PLANNING AND ZONING BOARD
REGULAR MEETING
April 18, 2016
6:00 p.m.

SAMS CROSSING

ARB SUBMITTAL

To: Planning and Zoning Board
From: City Staff
Date: April 5, 2016
RE: South City Partners Mixed Use Project-2702, 2718, 2730, 2734 East College Avenue

1 SITE PLAN

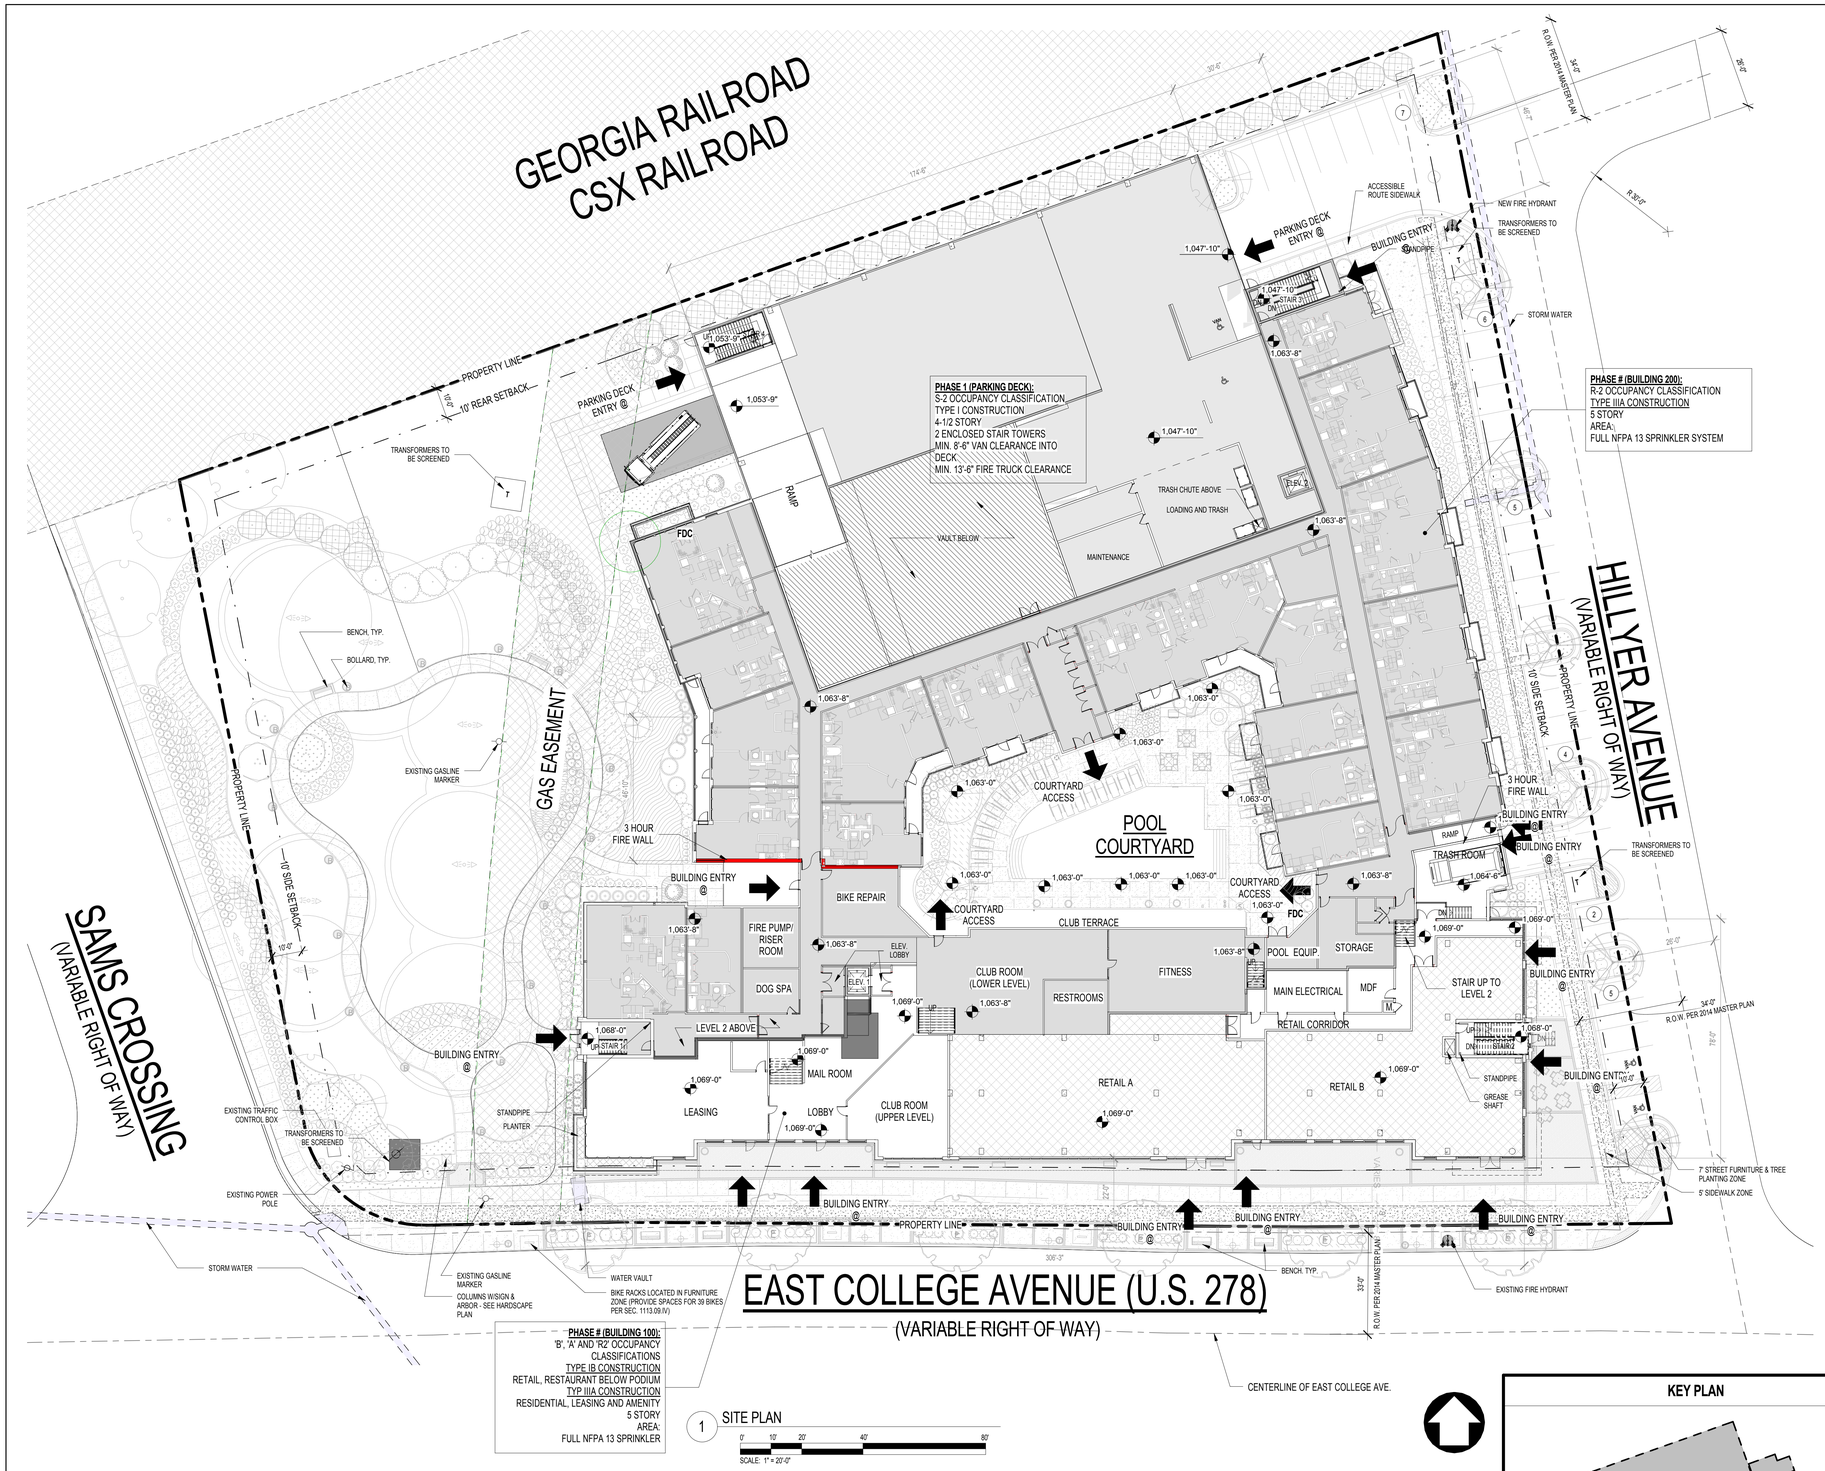
Staff Notes: There is only an 8'sidewalk with no real street furniture and tree planting or supplemental zone on Hillyer Street.

Staff Notes: The street furniture and tree planting zone is not continuous along Hillyer Street. The area consists of parking and tree planting. There is an 8'sidewalk which would meet the 5' sidewalk clear zone.

1) The applicant will add 2 parking spaces on the Hillyer Street side of the project and eliminate a parking space in the center of the block to make space for an additional tree, making the street trees closer to 60 feet on center; and
2) On the East College Avenue side of the project, encourage the applicant to increase the proportion of soft scape, greenscape in the street tree planting zone as opposed to concrete.
